Product Change Notification

Product Group: TC/Mon Feb 7, 2022/PCN-TC-001-2022-REV-0

Addition of Lot ID code to product marking for T52 family

T52 E5 ID code

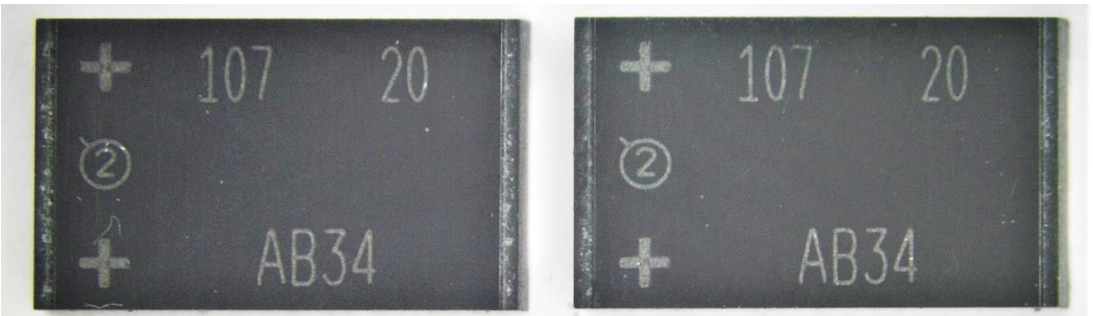
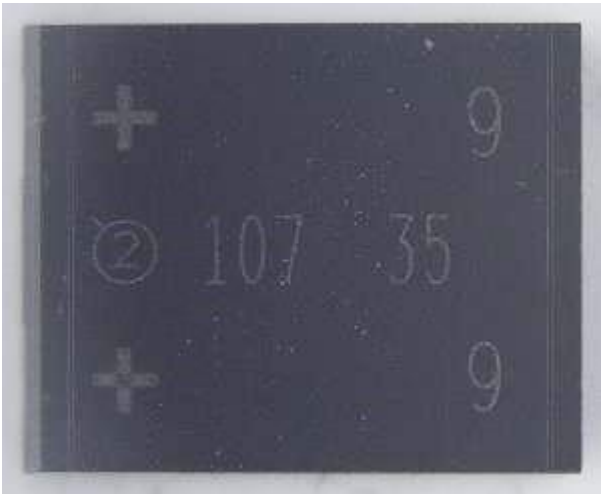
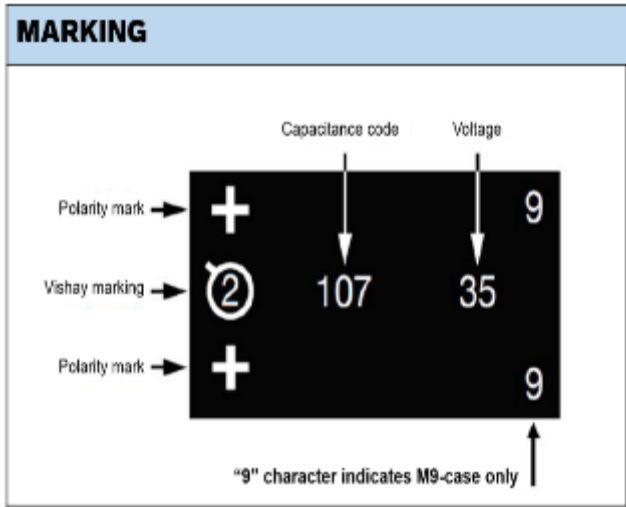
DESCRIPTION OF CHANGE: Add four digit Lot ID code to capacitor marking in order to provide individual unit traceability.
